June 19, 2025

RE: L.G. Everist, Inc.
Ragsdale Reservoirs, Permit #M-2020-007
Adequacy Response #3

Exhibit E – Reclamation Plan

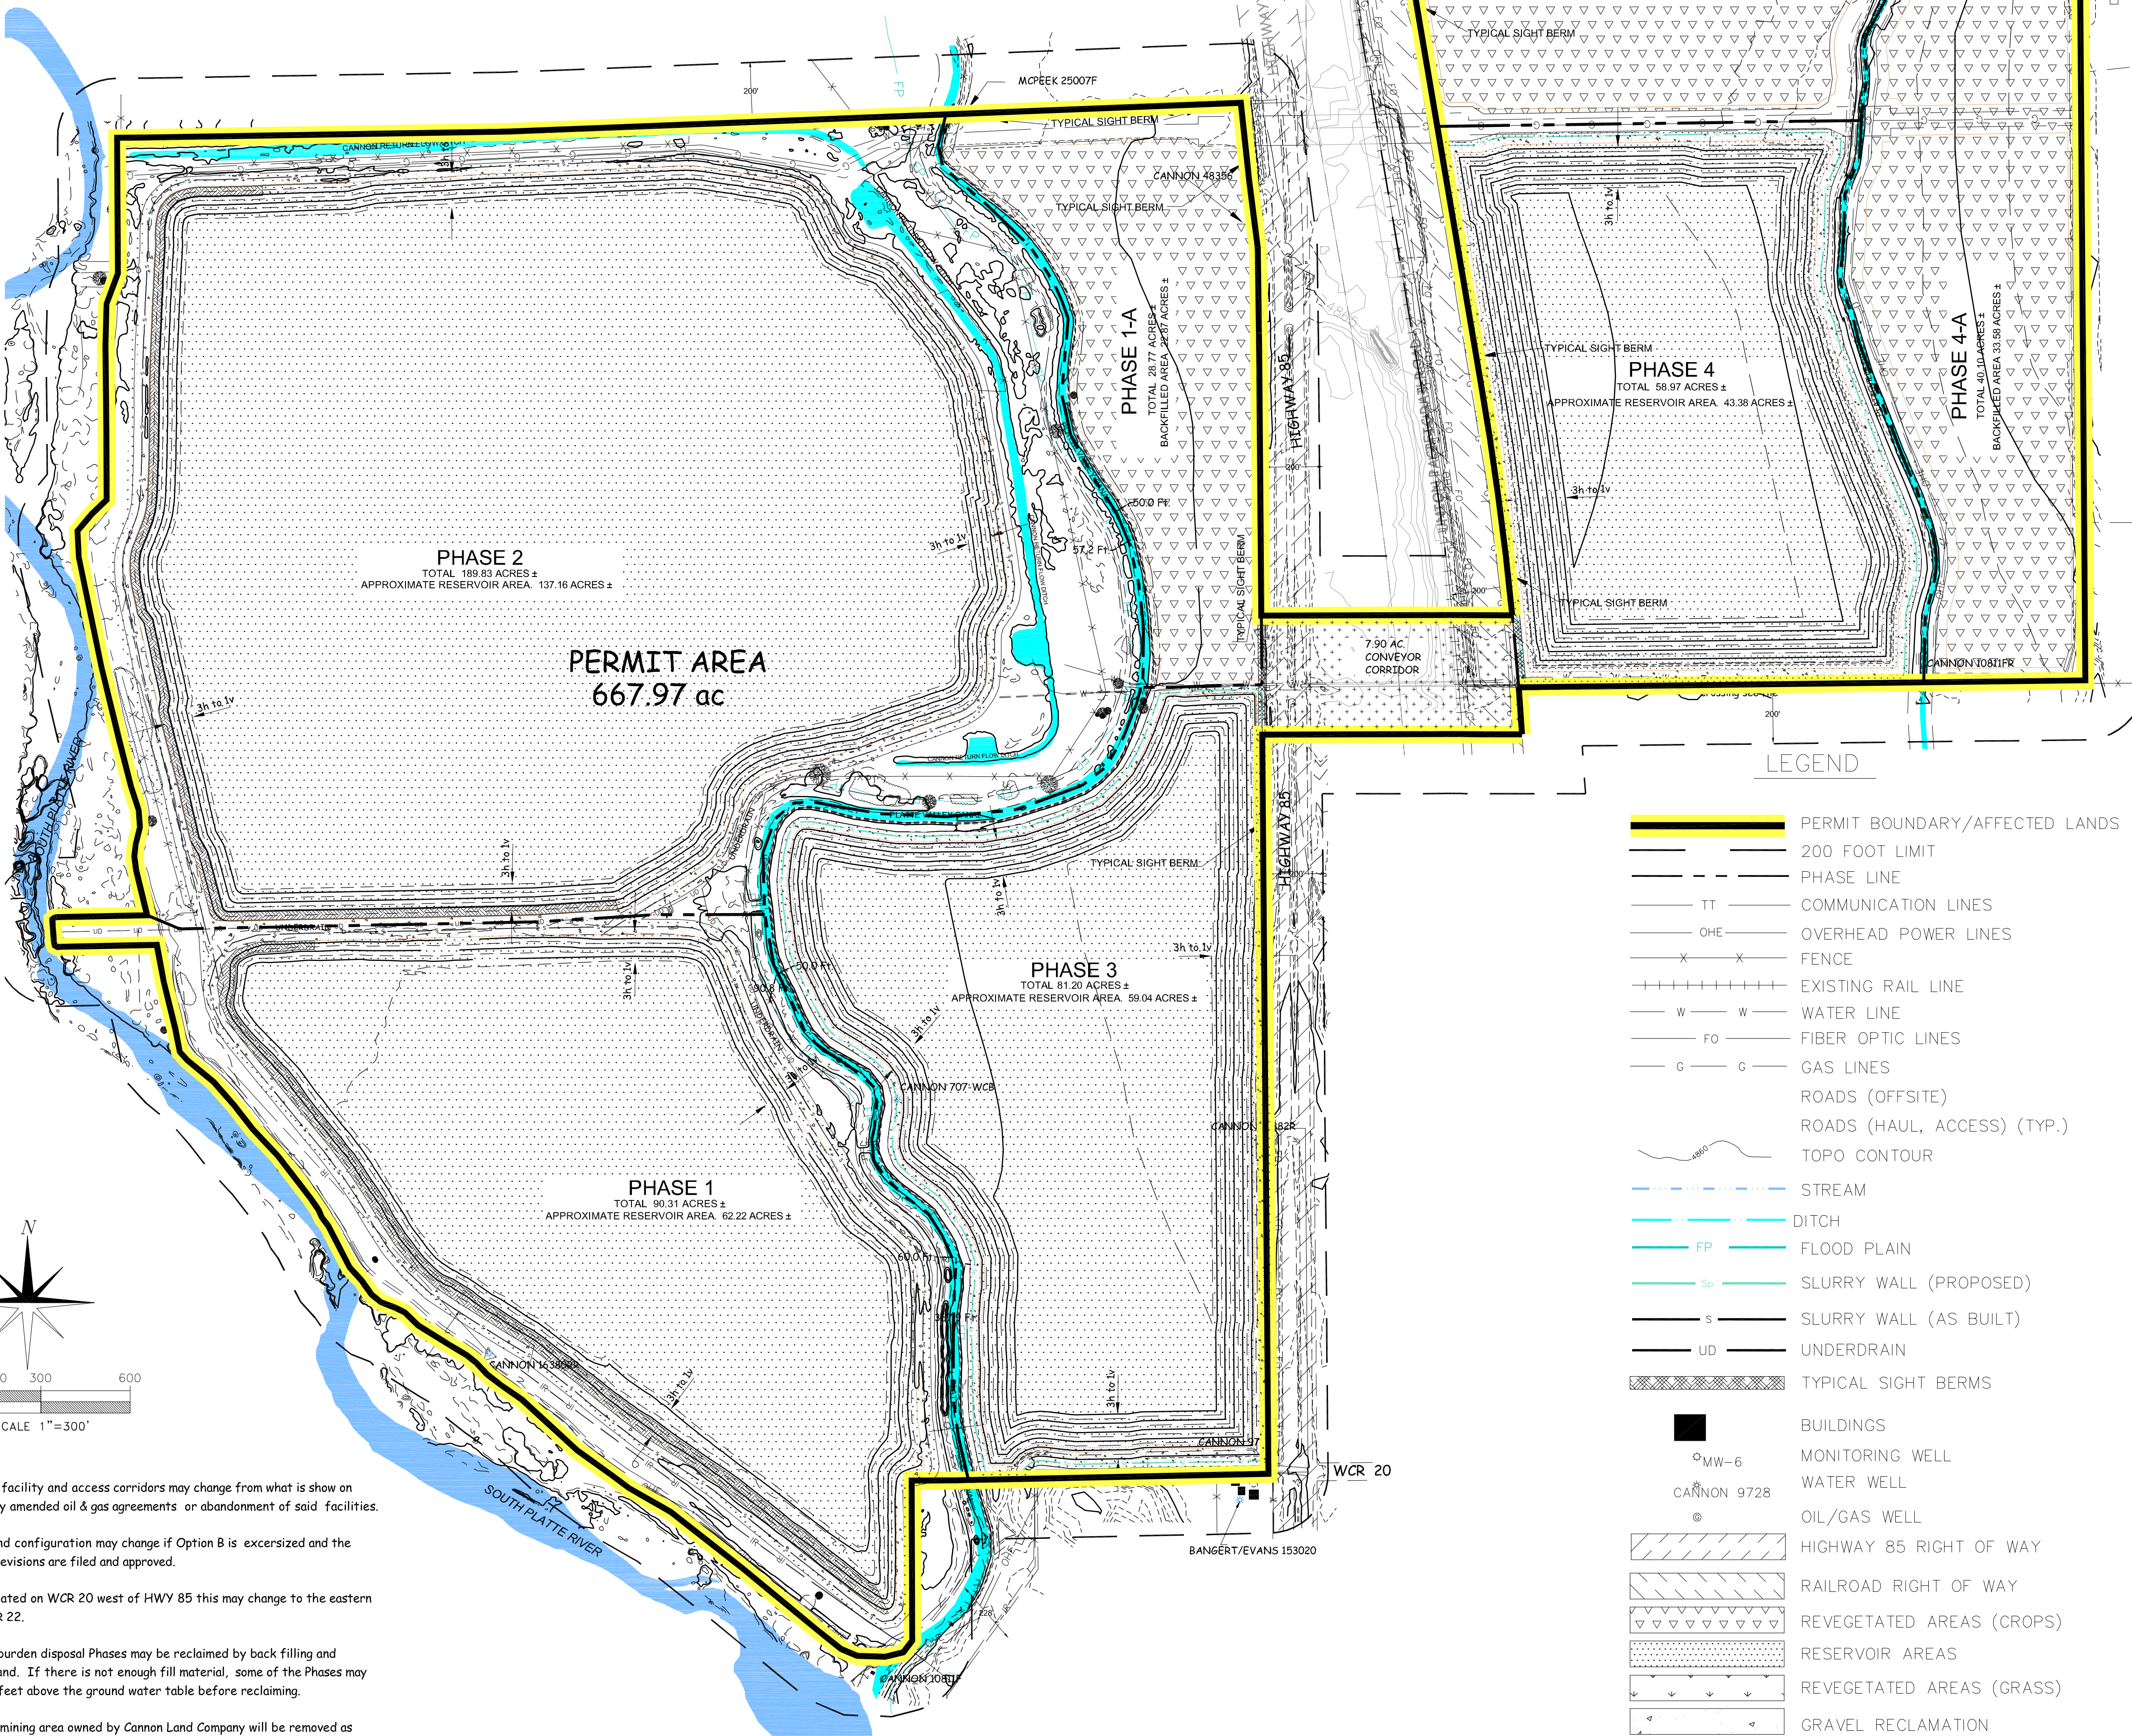
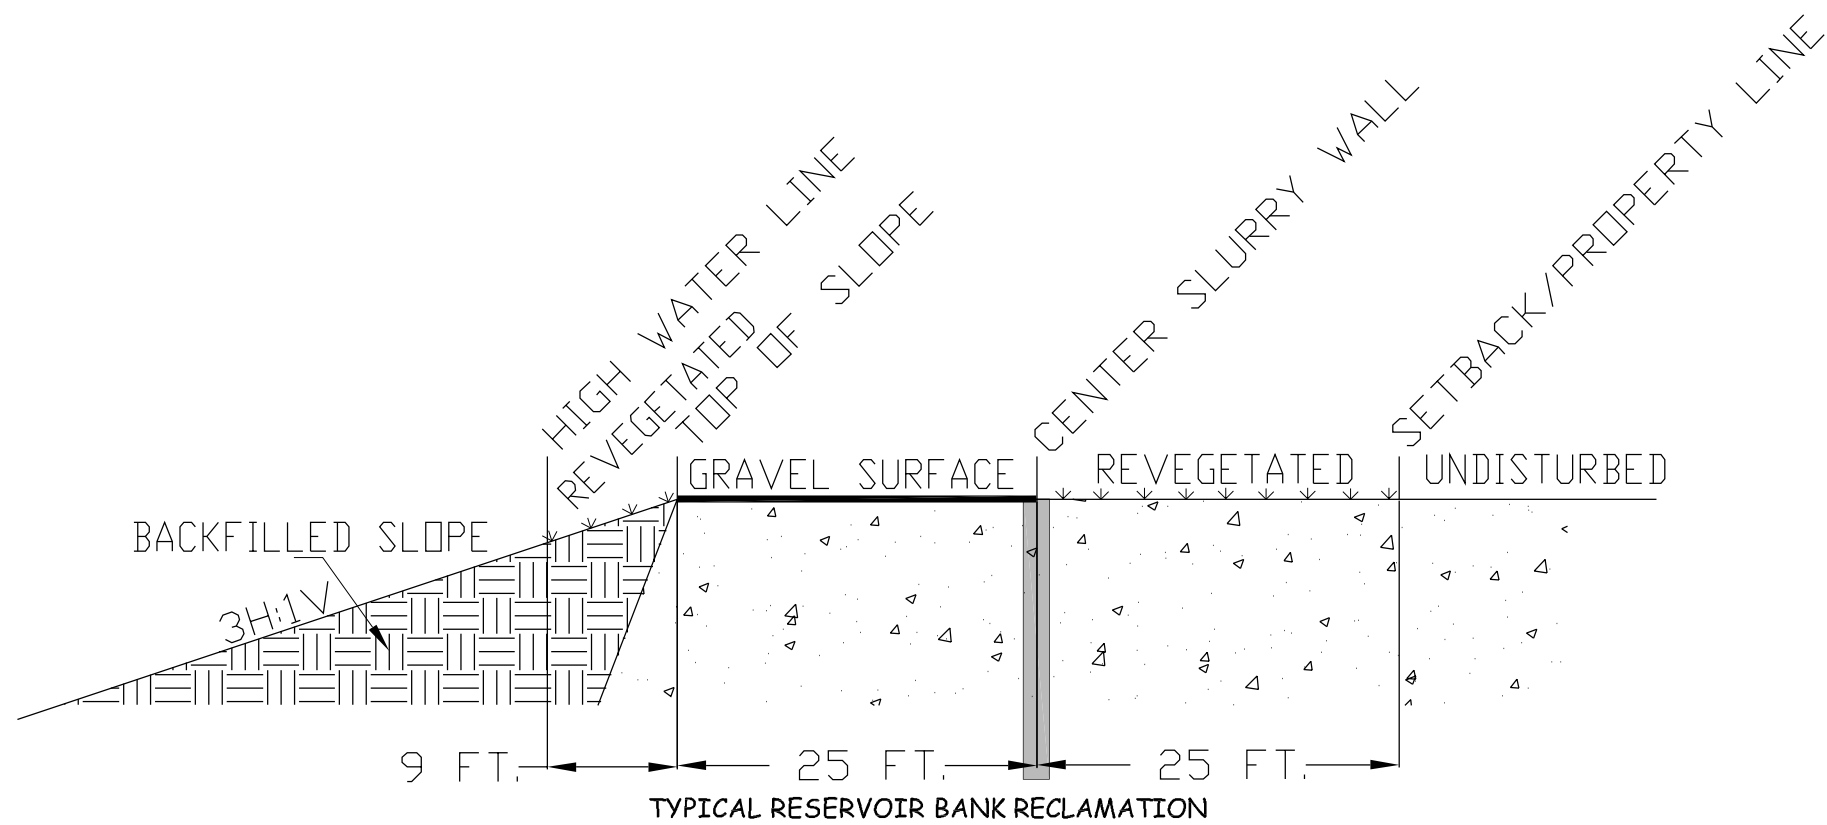
The Operator proposes to leave a gravel band around the reservoirs between the high-water line and the slurry wall. The slopes will be graded to 3H to 1V and no soil cover or vegetation is proposed. Per Rule 6.5(2) and Rule 3.1.5, please demonstrate how the placement of gravel alone will ensure stability of the reclaimed slope, control erosion and prevent slides or other damage to the pit slopes without established vegetation or the placement of rip rap for stabilization.

Upon review of the Division request for an analysis how gravel will prevent erosion on reservoir banks, LGE has decided to use the Divisions recommendation, and resoil and seed the bank slopes from the top-of-slope to the estimated highwater line in each reservoir, where no armoring is planned. Armored area will not be seeded or resoiled. We reviewed the **Mining Plan – Exhibit D** and the **Reclamation Plan – Exhibit E** and have revise as the plans appropriately to commit to resoiling and seeding bank slopes. We also removed reference to early release "upon owner approval", and will work with the reservoir owners to accommodate their plans until the Division deems reclamation is complete.

Exhibits FA and FB – Reclamation Plan Maps were revised to show the gravel band on the flat area between the slurry wall and the top-of-slope with revegetation taking place on areas outside the slurry wall and on the bank slope to the highwater line. The
